UNITED STATES PATENT AND TRADEMARK OFFICE

APPLICATION NO.	FILING DATE	FIRST NAMED INVENTOR	ATTORNEY DOCKET NO.	CONFIRMATION NO.
10/825,224	04/16/2004	Johannes Petrus Martinus Bernardus Vermeulen	081468-0309212	7269
909	7590	08/08/2005	EXAMINER	
PILLSBURY WINTHROP SHAW PITTMAN, LLP P.O. BOX 10500 MCLEAN, VA 22102			MULLINS, BURTON S	
			ART UNIT	PAPER NUMBER
			2834

Office Action Summary	Application No.	Applicant(s)	
	10/825,224	VERMEULEN ET AL.	
	Examiner	Art Unit	
	Burton S. Mullins	2834

DETAILED ACTION***Drawings***

FIG. 5

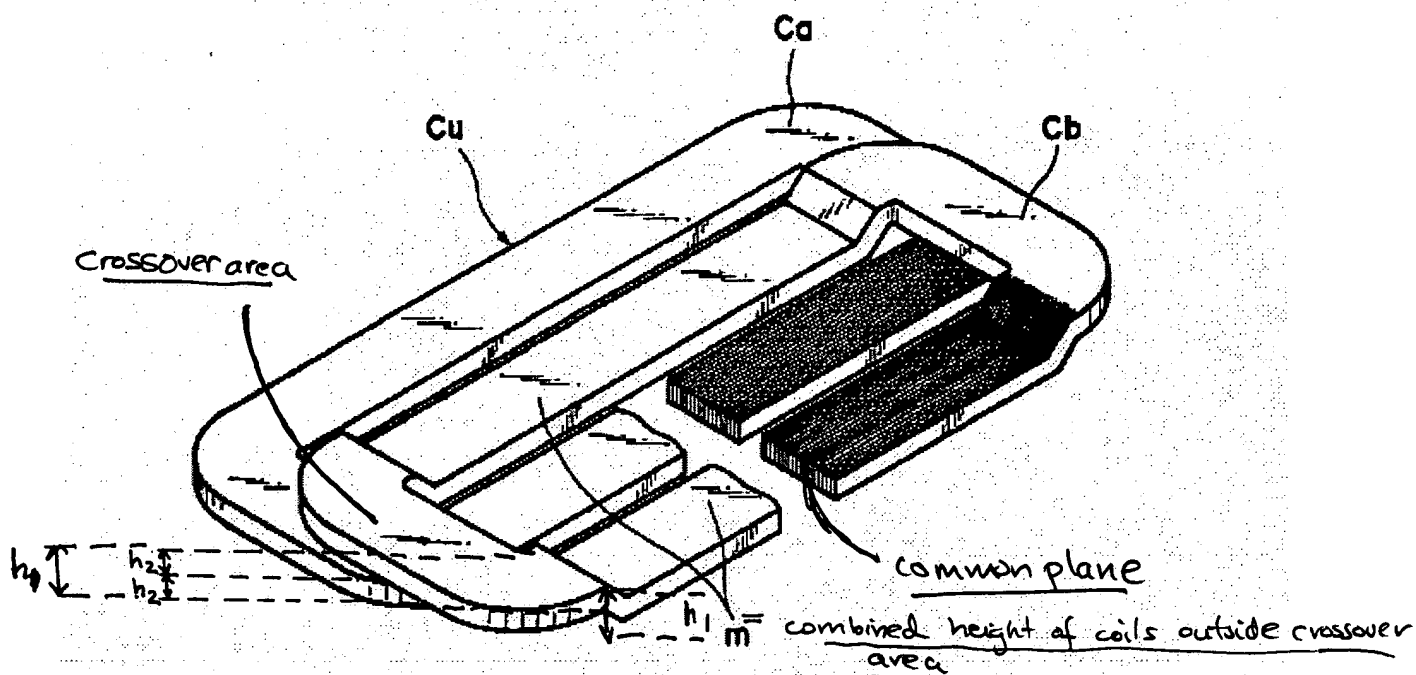
5. Claims 1, 3, 5-12 and 16-18, as best understood, are rejected under 35 U.S.C. 102(b) as being anticipated by Korenaga (US 6,265,793). Korenaga teaches a coil assembly (Fig.5) including at least one first coil (Ca); and at least one second coil (Cb), wherein the coils are arranged in a common plane, the at least one first coil and the at least one second coil overlapping one another partially and defining at least one crossover area where respective crossover sections of the at least one first coil and the at least one second coil cross one another, and the crossover sections having a respective crossover section height h_2 perpendicular to the common plane, the combined crossover section heights of the crossover sections in the crossover area equal at most a height h_1 of one of the at least one first coil and the at least one second coil outside the at least one crossover area.

Fig. 3

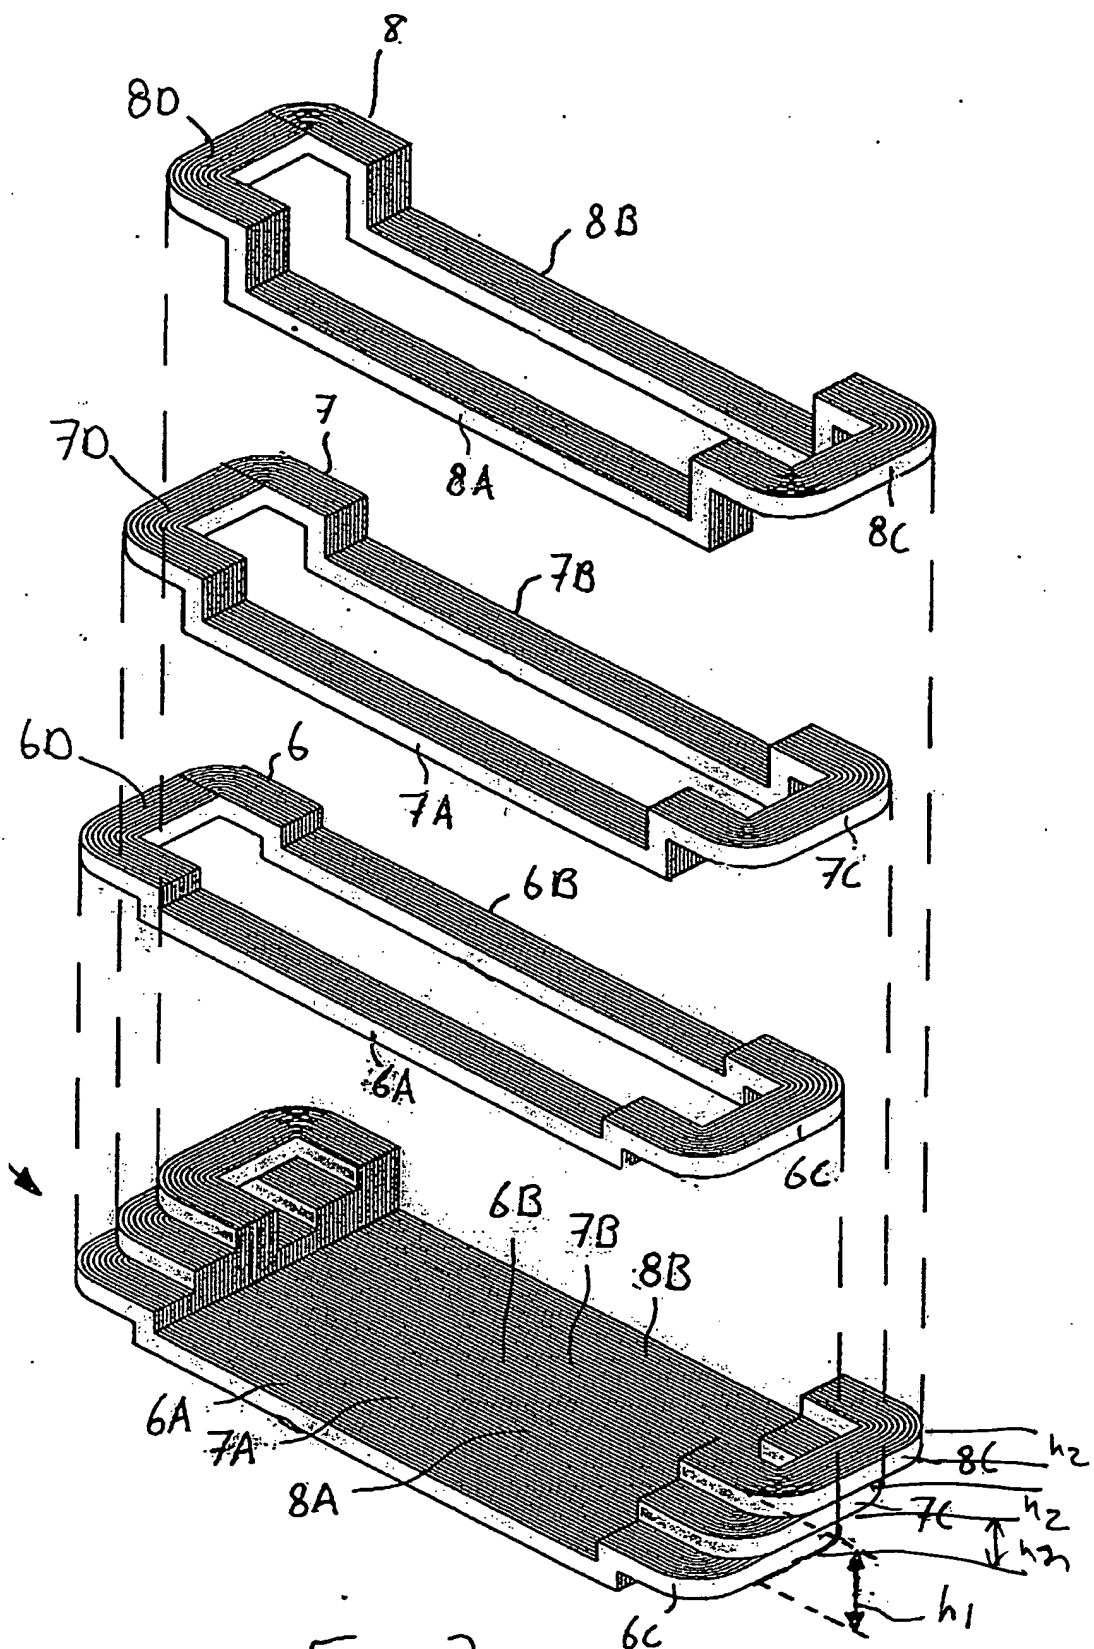
1. The drawings are objected to because Figs.4-5, while purporting to show the claimed invention, appear to simply show the prior art construction of Fig.3 from different perspectives. For example, h1 in Fig.3 is also shown in Fig.5 and refers to the same dimension, the total thickness of the crossover. Fig.4 appears to be a top view of the prior art coil system of Fig.3, with coil sections 7A/B and 8A/B placed in the open area of coil 6A/B, in the same plane. In other words, the drawings do not clearly show the features of the claimed invention.

In claims 1, 8 and 10-11, recitation “the combined crossover section heights of the crossover sections in the crossover area equal at most a height of one of the at least one first coil and the at least one second coil outside the at least one crossover area” is vague and indefinite because it is not clear if this means the combined crossover section height, i.e., $h_2 + h_2 + h_2$ in Fig.5, is less than or equal to the total height of all the coils outside the crossover area, i.e., h_1 in Fig.5, or if the sum is less than the height of any one of the coils. The specification seems to suggest the former interpretation (see p.12, paragraph 53; Fig.5); however, the language “one of the at least one first coil and the at least one second coil” also implies an interpretation wherein the combined cross-over height is at most a height of either the first coil or the second coil. For purposes of examination, the former meaning will be taken, with the stated height limitation shown in Fig.5 as h_1 . If the latter meaning is intended, the drawings should be corrected because h_1 in Figs.3&5 currently denotes the height of all the coils outside the crossover area.

4. Claims 1-18, as best understood, are rejected under 35 U.S.C. 102(b) as being anticipated by applicant's admitted prior art. Figs.2-3 and pp.1-3 and 11-12 teach the prior art coil assembly including, with reference to the attached marked copy of Fig.3, at least one first coil (6); and at least one second coil (7), wherein the coils (6A/6B and 7A/7B) are arranged in a common plane, the at least one first coil and the at least one second coil overlapping one another partially and defining at least one crossover area where respective crossover sections of the at least one first coil (6) and the at least one second coil (7) cross one another, and the crossover sections having a respective crossover section height h_2 perpendicular to the common plane, the combined crossover section heights of the crossover sections in the crossover area equal at most a height h_1 (spec. p.11, last line-p.12, first line) of one of the at least one first coil and the at least one second coil outside the at least one crossover area.

$3h_2 < h_1$
same
as
Fig 5?

not clear
what applicant
means or how
cross over heights
distinguish

Fig. 5

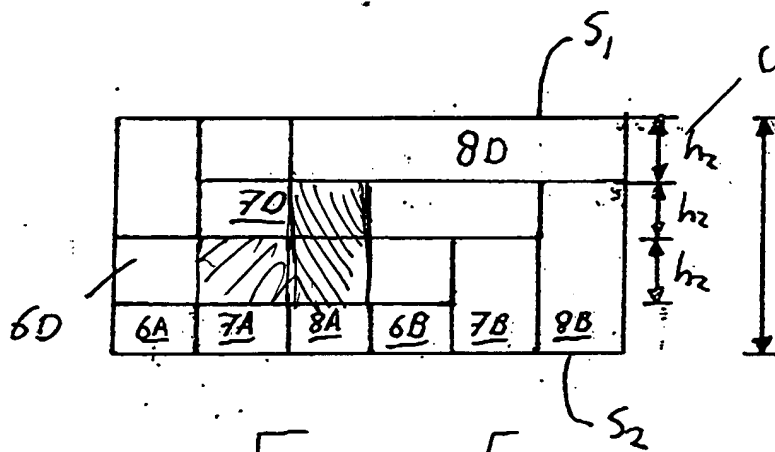
Crossover height
what is h_1 combined
heights outside
 $3h_2 < h_1$ ~~total area~~
~~area~~
or just height
of 1 coil outside
x-over area??
